Midpeninsula Regional
Open Space District

R-12-15
Meeting 12-09
March 14, 2012

Approval of an Addendum to the Mitigated Negative Declaration and Corrected Mitigation Monitoring Program for the El Corte de Madera Creek Parking/Staging Area and Trails Project (Project) in Accordance with the California Environmental Quality Act to Incorporate San Mateo County's Required Project Modifications

Technical Addendum Pursuant to California Environmental Quality Act Guideline 15164 El Corte de Madera Creek Open Space Preserve Parking/Staging Area and Trails Project

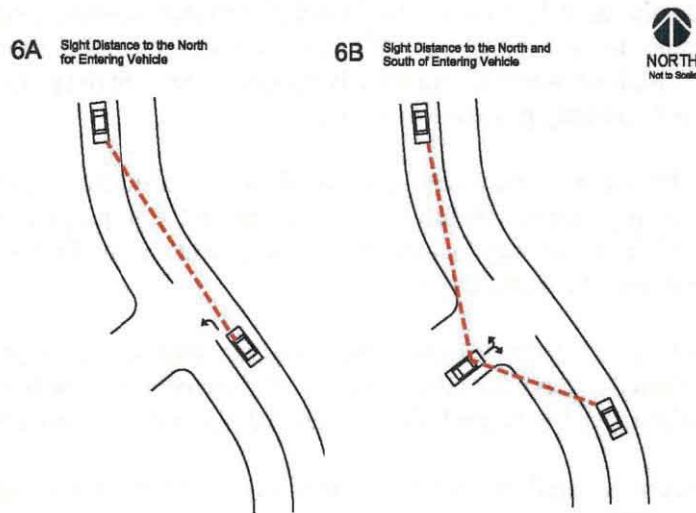
Sight Distance at the Project Driveway. Curves are present on the roadway segments north and south of the project driveway. North of the project driveway, the maximum speed was determined to be 49 mph. The required minimum stopping sight distance for this maximum speed (per Caltrans Highway Design Manual, Table 201.1) is 415 feet. South of the project driveway, the maximum speed was determined to be 38 mph. The required minimum stopping sight distance for this location is 280 feet.

For entering left turning vehicles (Figure 6A), the line of sight is approximately 447 feet. Since the available line of sight (447 feet) is greater than the minimum stopping sight distance (415 feet), the sight distance at this location is satisfactory.

For exiting left and right turns at the site driveway (Figure 6B) the line of sight is 512 feet from the north. As described above, the required minimum stopping sight distance from the north is 415 feet.

The line of sight is 498 feet to the south. As described above, the required minimum stopping sight distance from the south is 280 feet. Since the available lines of sight north and south are greater than the minimum stopping sight distances, the sight distance at this location is satisfactory.” (Excerpt and graphic from memorandum from Hexagon to Ana Ruiz, Planning Department Manager, June 30, 2009)

Attachment 4 - North and South Driveway Comparison Map

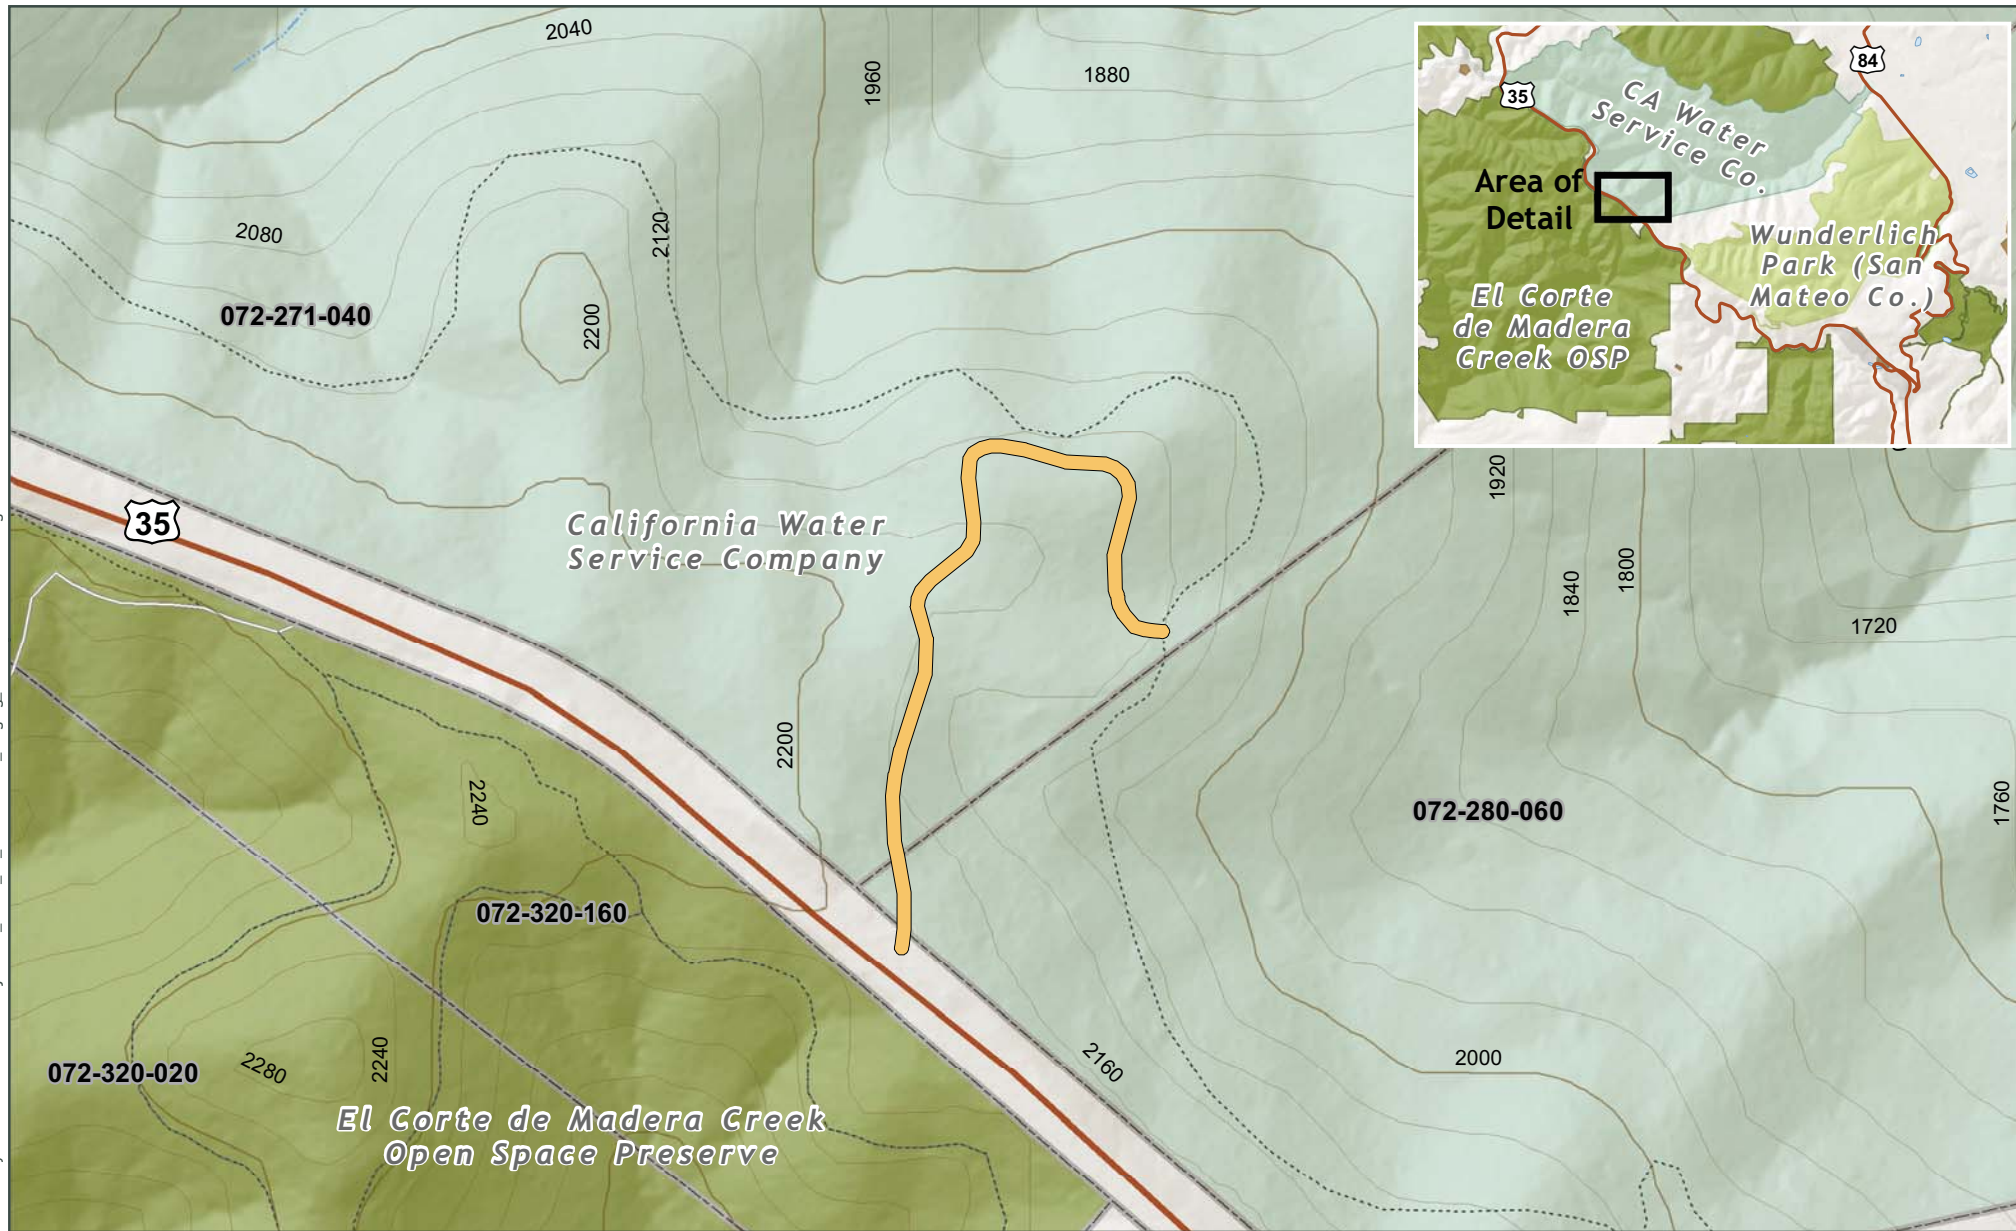
1. Move the proposed driveway entrance 100 feet south (see Attachment 4). It is important to note that the relocated driveway entrance exceeds all of Caltrans' sight distance requirements for safe vehicle ingress and egress from the driveway (see Attachments 3 and 6). In addition, the relocation results in less overall project grading and less tree removal.

As a condition of approval, the San Mateo County Planning Commission has required that the driveway entrance be moved 100 feet south. For the purposes of this Addendum, the driveway entrance location initially submitted as part of the permit application is referred to as the North Driveway and the modified driveway entrance location as the South Driveway.

The relocation of the driveway entrance to the south will result in less environmental disturbance than the North Driveway location. Even though potential project impacts have already been mitigated to a less than significant level, the South Driveway is shorter than the North Driveway and there is 15% less overall grading. Due to existing topography, a new culvert is required to improve drainage, but the small area of disturbance for the culvert still would result in less grading overall for the South Driveway as compared to the North Driveway. In addition, no change in grading would be necessary for the staging area itself as relocation of the driveway entrance would not change the design of the staging area.
